CONVAIR

COMMERCIAL CHANGE PROPOSAL

CUSTOMER: Alaska Airlines Inc.

MODEL 22-21(#2) (Convair "880")

GENERAL ARRANGEMENT

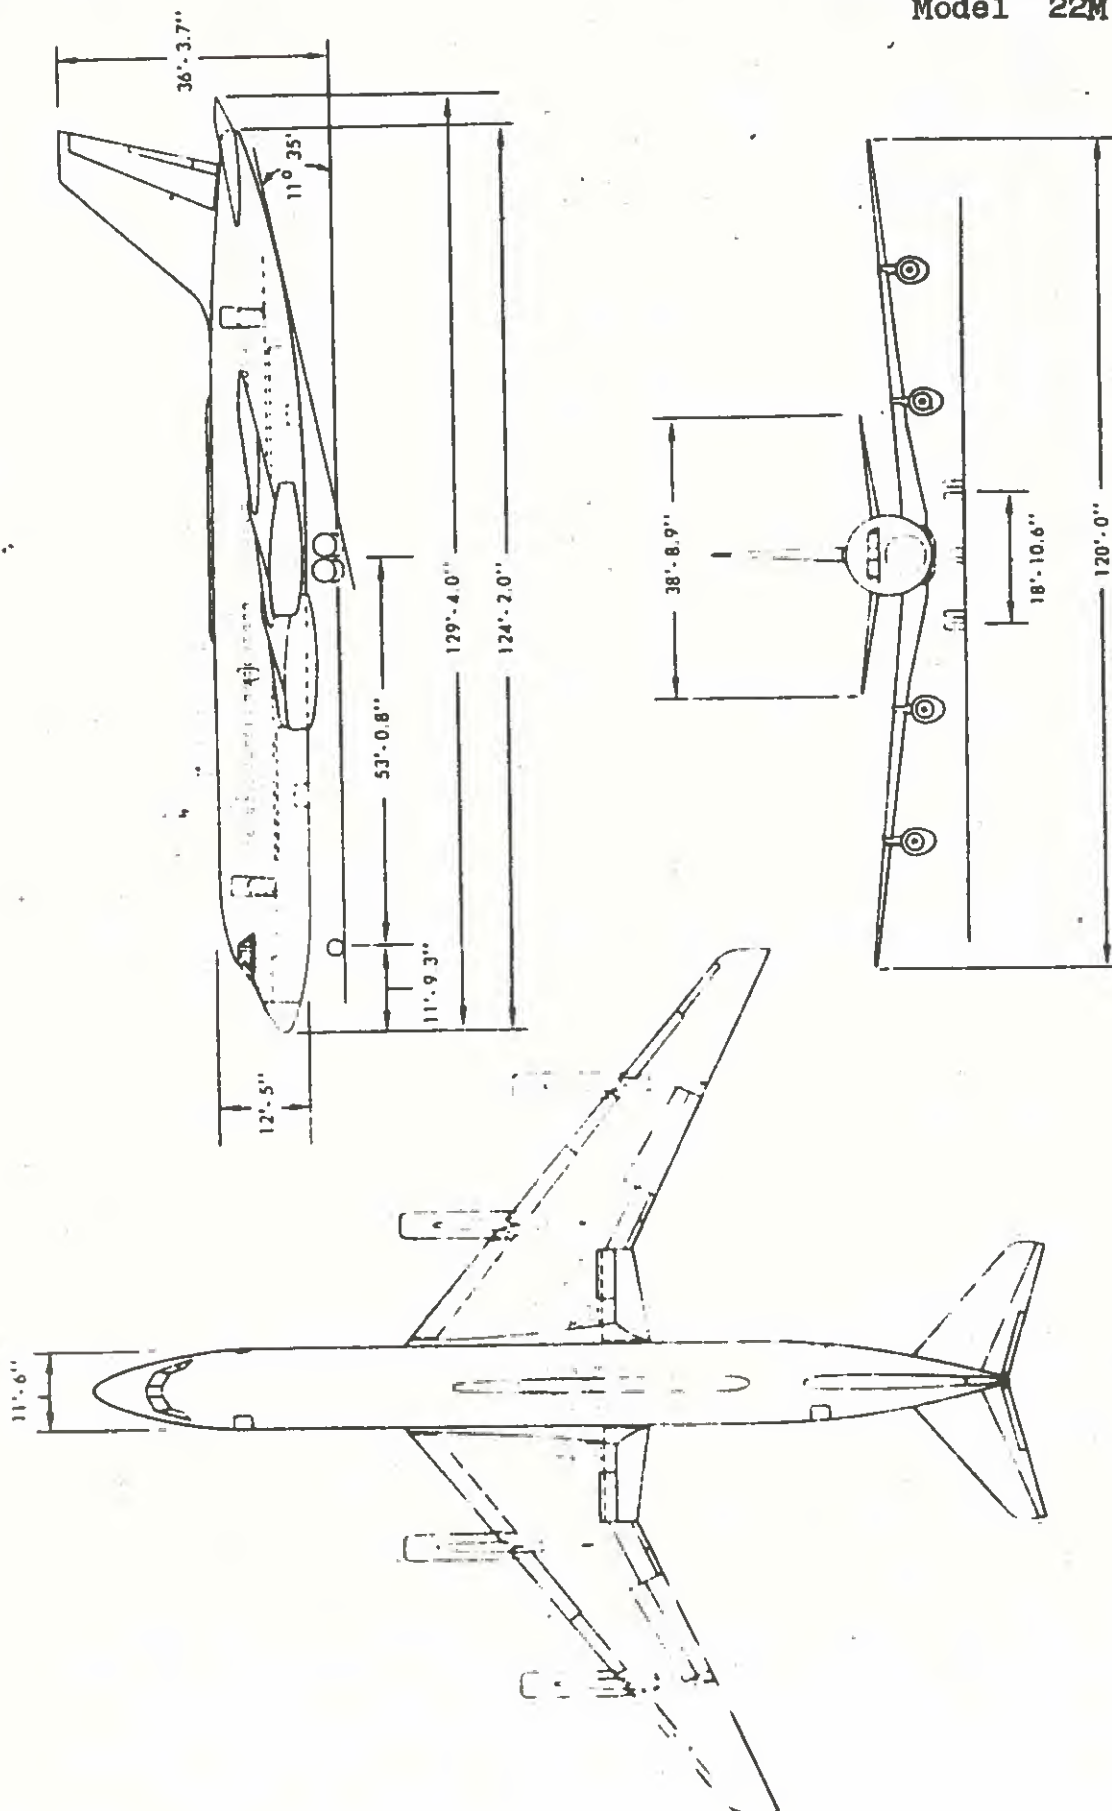
Page 3a, GENERAL ARRANGEMENT:

Replace above illustration in the specification with Enclosure (A) which shows Krueger Flap installation between inboard pylon and fuselage, and trailing edge inboard flap extension.

Enclosure: (A) One copy Page 94a - GASEOUS OXYGEN SYSTEM (Revised)

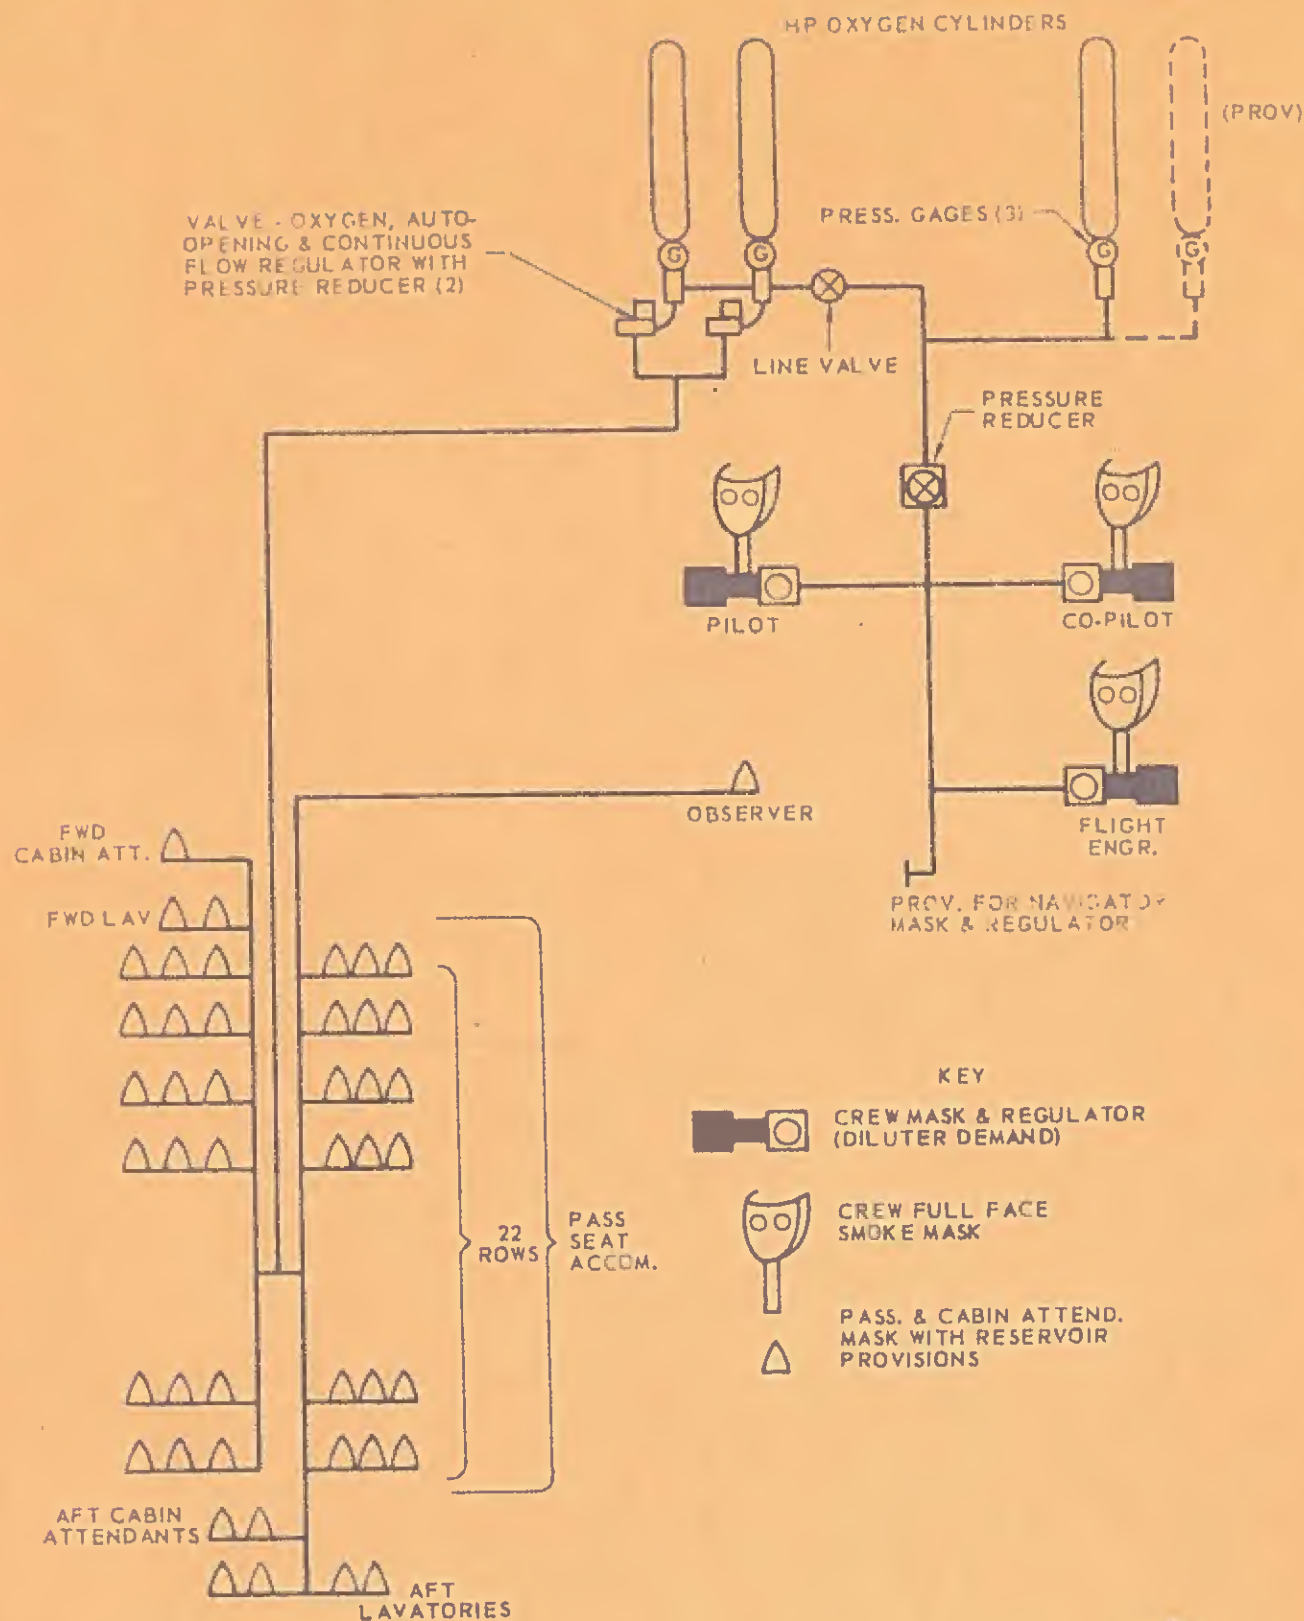
Replace above illustration in the specification with Enclosure (A) which shows provisions for a navigator mask and regulator.
